***MODIFICATION REQUEST:
VINCENTIA COASTAL VILLAGE
Naval College Road, Vincentia***

Description of Modification No. 9 Request

Figure 3: Proposed staging sequence for the Western Village
NSW Government
Department of Planning

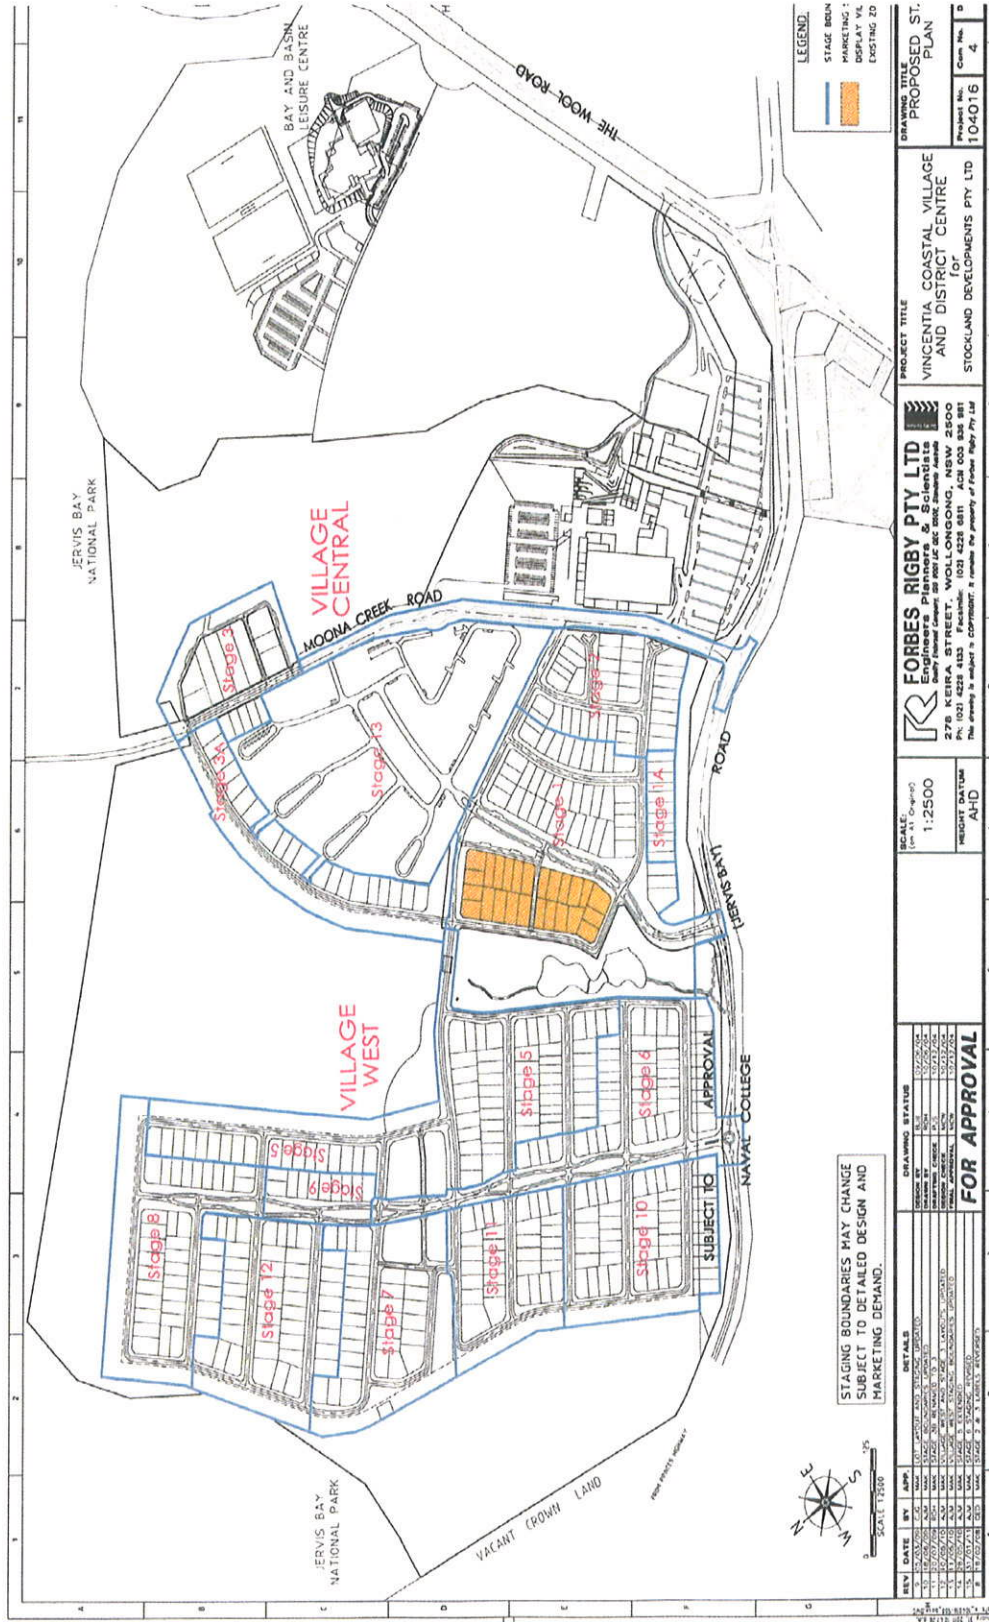
In response to these objections the proponent has revised the proposed timing for the construction of this roundabout. They advise that Stage 5, which contains 82 lots (see plan at **Tag 10**), is currently under construction and that Stage 6, which contains 25 lots, will be the next stage to be constructed, with its completion expected by the end of 2011. They propose that the trigger for the construction of this roundabout is now the completion of Stage 6, rather than *"prior to the issuing of the Subdivision Certificate for the 400th lot"*. In this situation, the maximum amount of traffic from the Western Village that will pass through the Central Village will be that generated by the 82 lots in Stage 5.

The current Statement of Commitment requires Access A to be constructed prior to the completion of Stage 9. Given that the original Stage 9 generally accords with the proposed Stage 6 (refer to staging plan at **Tag 11**), this revised arrangement is consistent with the originally approved timing for the construction of Access A.

However, for clarity the Department recommends that a condition be added to the Project Approval specifically stating that the roundabout is to be constructed as part of the Stage 6 works and that the Subdivision Certificate for Stage 6 or any other stage in the Western Village is not to be issued until the roundabout at Access A has been completed.
